Enclosure (1) is the Final Parcel E Nonstandard Data Gaps Investigation Landfill Lateral Extent Evaluation. This report is provided for your information.

Enclosure: 1. Final Parcel E Nonstandard Data Gaps Investigation Landfill Lateral Extent Evaluation, Hunters Point Shipyard, October 29, 2004

This document discusses data collected for, and results of, an investigation to assess the extent of solid waste at the Industrial Landfill in Installation Restoration Site 01/21 of Parcel E (hereinafter referred to as the Landfill) at Hunters Point Shipyard (HPS) in San Francisco, California. This work was conducted as part of the Parcel E nonstandard data gaps investigation under the protocols set forth in the "Draft Final Field Sampling Plan and Quality Assurance Project Plan [FSP/QAPP] for Parcel E Nonstandard Data Gaps Investigation (Industrial Landfill and Wetlands Delineation), HPS, San Francisco, California," dated January 8, 2002. This report is part of the revised remedial investigation and feasibility study for the Landfill at HPS. The results from this evaluation will be used to assist in development of the final remedy for the Landfill.

FIGURE 11
CROSS SECTION E-E'
 Final Parcel E Nonstandard Data Gaps Investigation
 Landfill Lateral Extent Evaluation

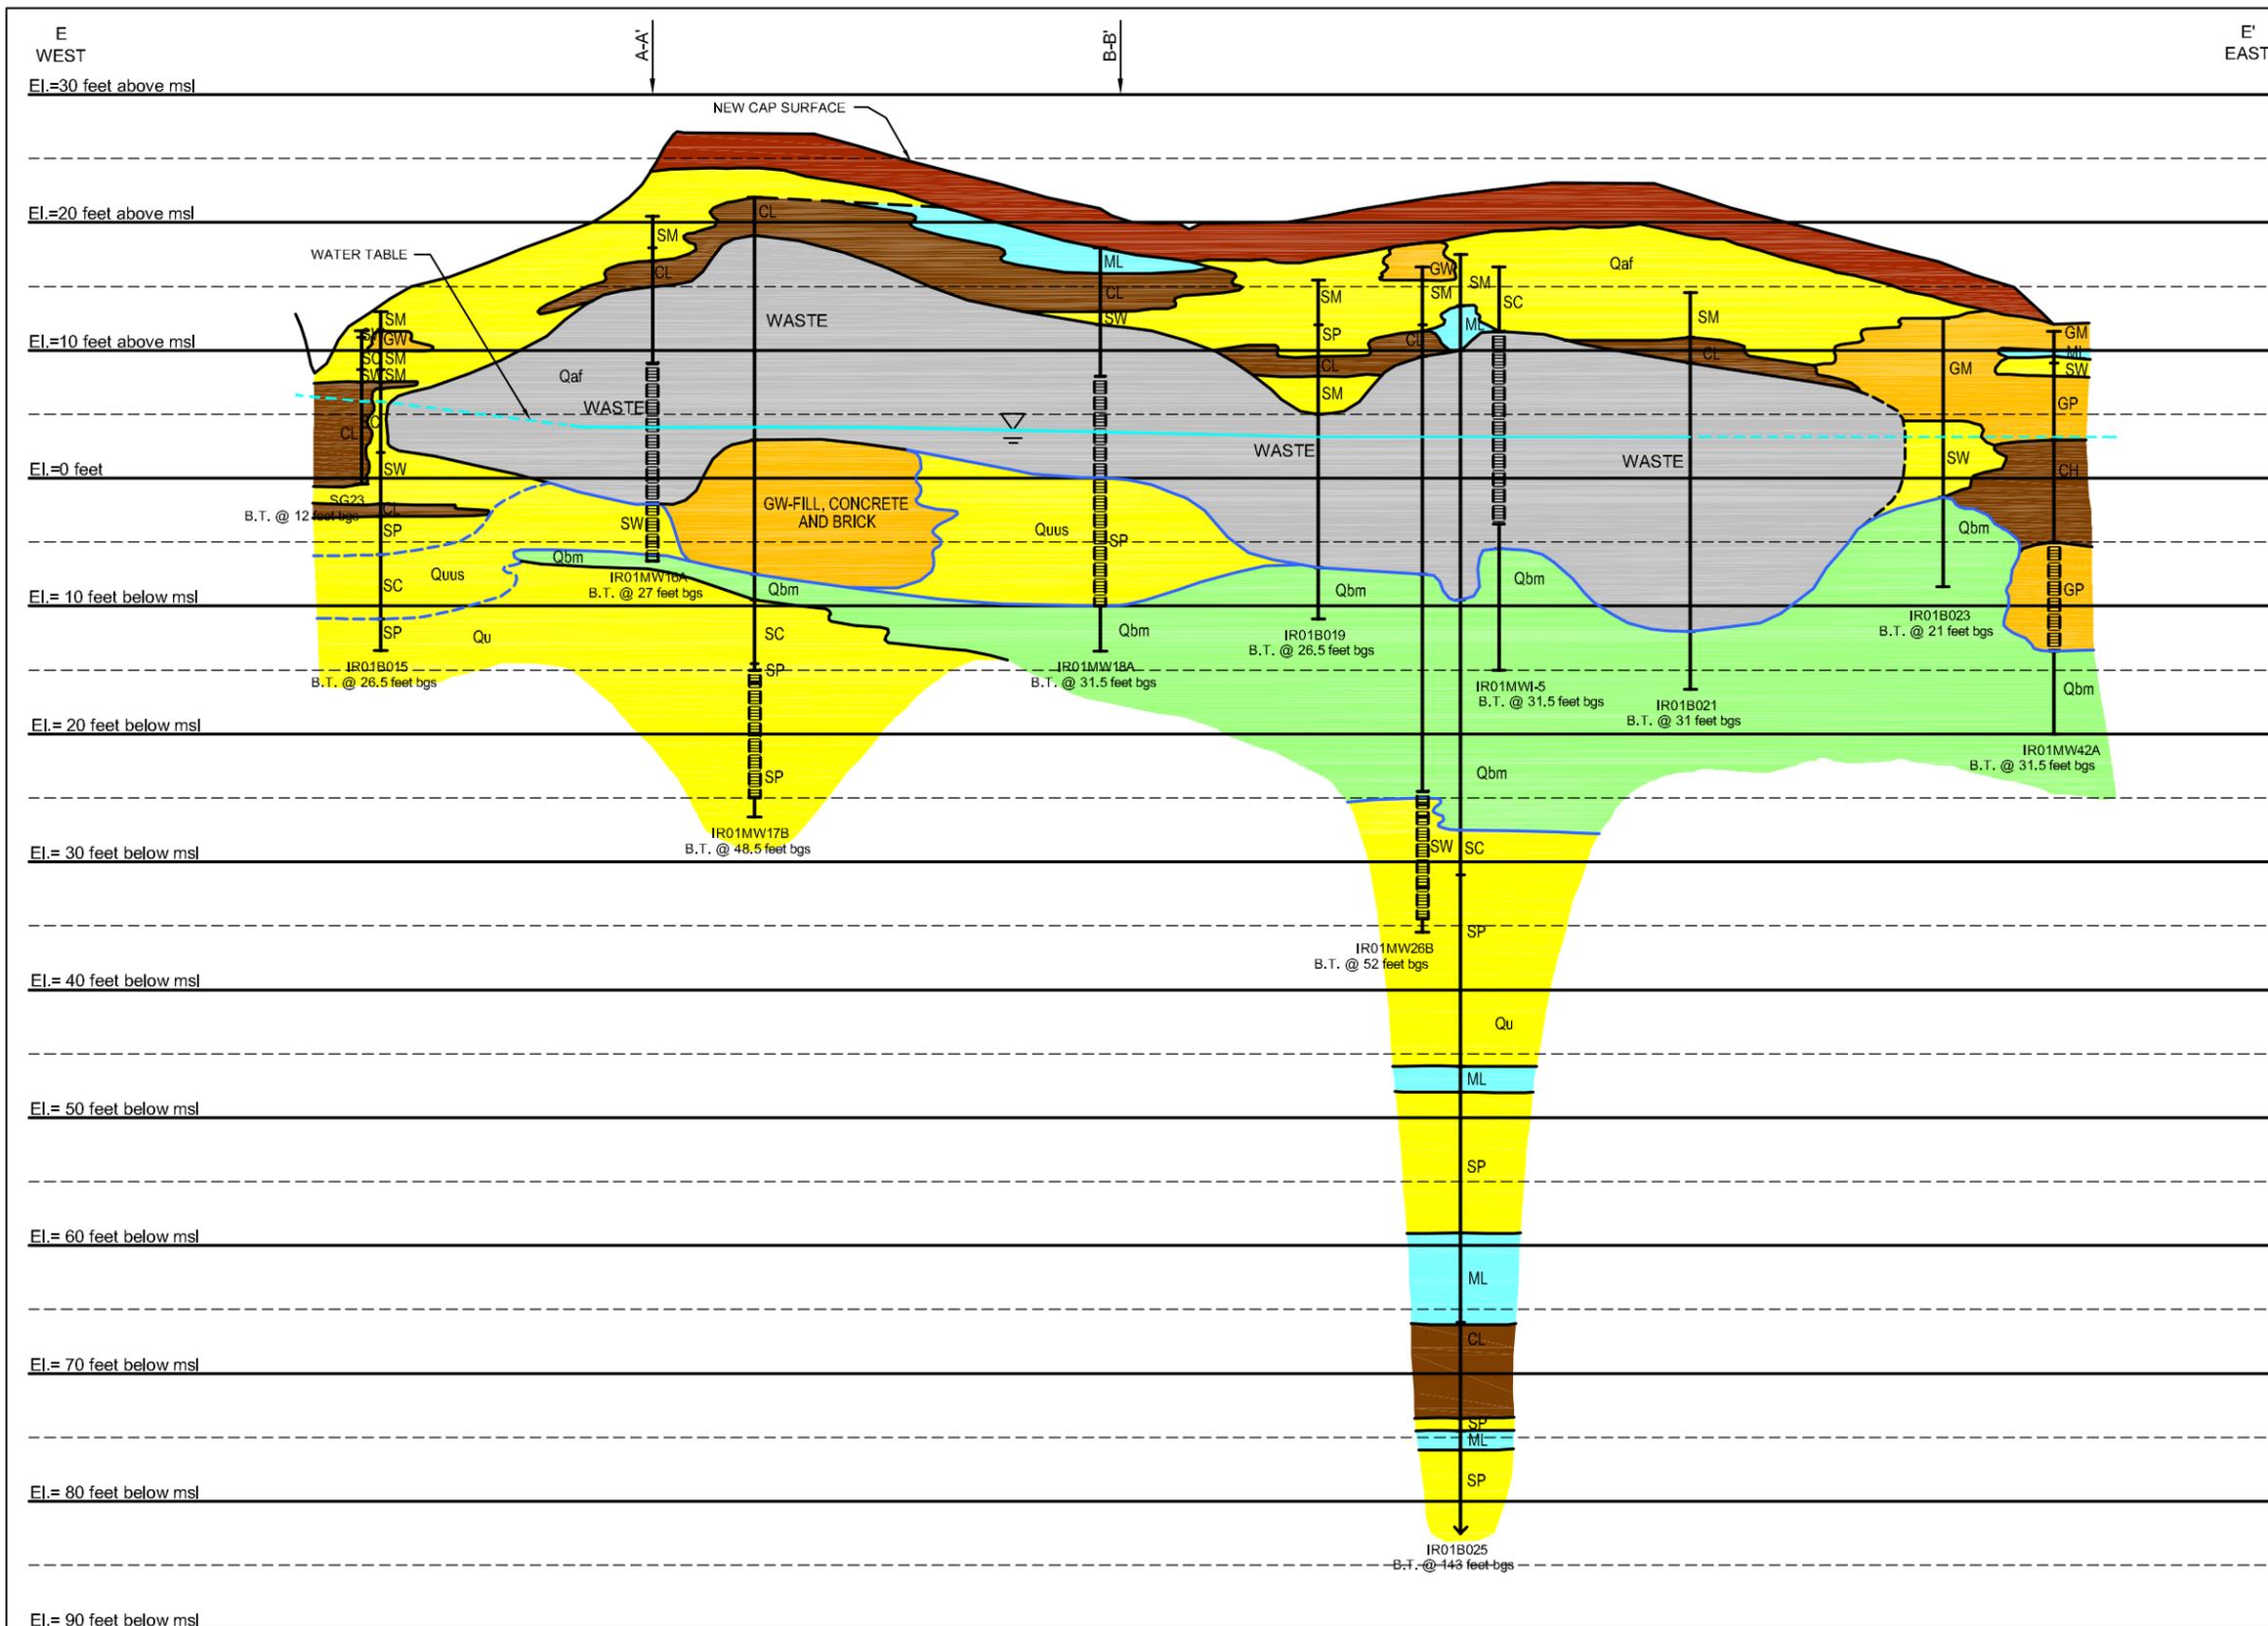
14. **Comment:** Figure 11, Cross Section E-E': There is no correspondence between the log for SG03 and the lithology shown on the cross section in the vicinity of this boring. The log for SG03 indicates that the lithology from 0 to 2 ft bgs is clay, and the unit below this is sand to 16 ft bgs, but the lithology on the cross section indicates that sand extends from 0 to 4 ft bgs and clay extends from 4 to about 14 ft bgs. As drawn, the lithology indicates an abrupt change between this boring and IR01B015, which is only located a few feet east of SG03, so it appears that the wrong boring log was used when the cross section was constructed. Please correct the lithology on the cross section.

Response: The boring log on Figure 11 was incorrectly labeled SG03 instead of SG23. The Navy has revised [Figure 11](#) of the final report to indicate that the log shown is SG23. However, the lithology for the log is correctly portrayed on the figure in the draft report, so the lithology has not been revised.

FIGURE 12
 CROSS SECTION F-F'

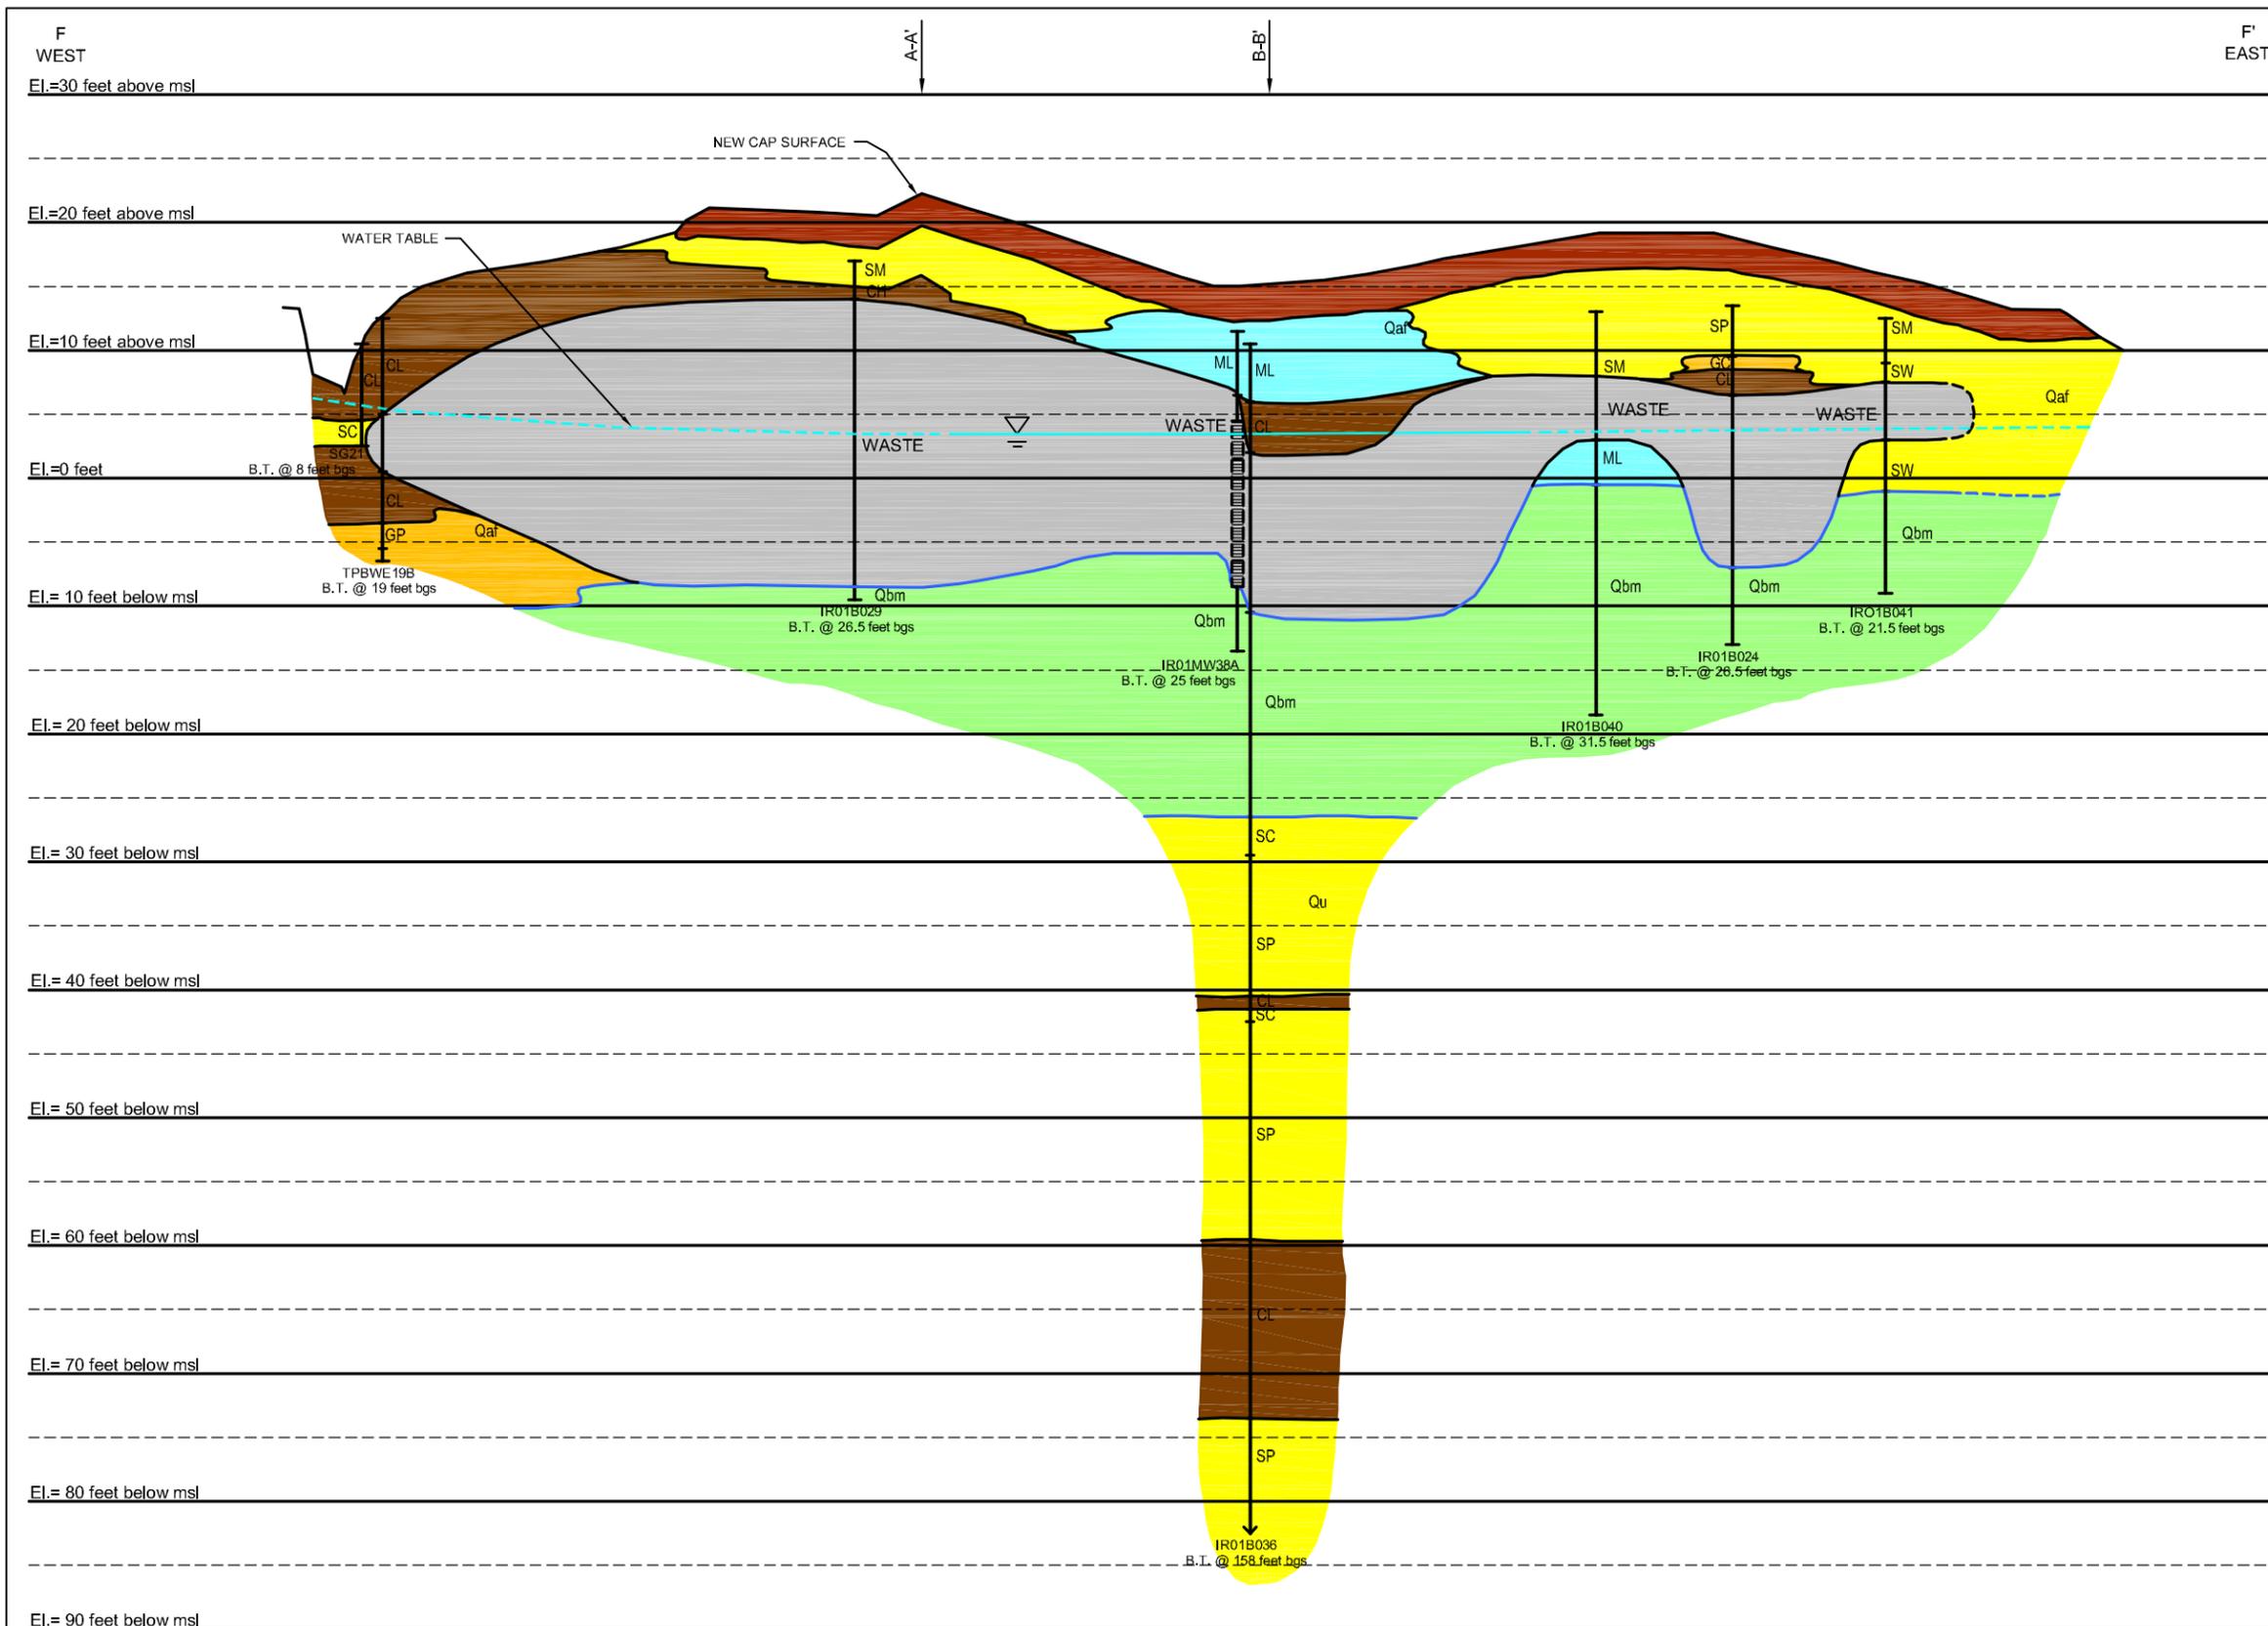
6. **Comment:** **Figure 8, Cross Section B-B' and Figure 12, Cross Section F-F':** The log for IR01MW38A indicates that the lithology in the bottom two feet of the well screen is a black fat clay with traces of aluminum. The presence of aluminum suggests that this is fill, not native materials. Please resolve this discrepancy.

15. Comment: **Figure 12, Cross Section F-F': The boring log of SG21 and the lithologic label (sc) on the cross section indicate that the lithology between 6 and 8 feet bgs is clayey sand, but the cross section uses the color for clay in this depth interval. Please resolve this discrepancy.**

Response: The Navy has revised [Figures 8 and 12](#) of the final report as requested. The 18- to 20-foot bgs depth interval on boring log IR01MW38A is now designated as waste.

Response: The Navy has revised [Figure 12](#) of the final report to show the color of sand for the 6- to 8-foot bgs depth interval of boring SG21.
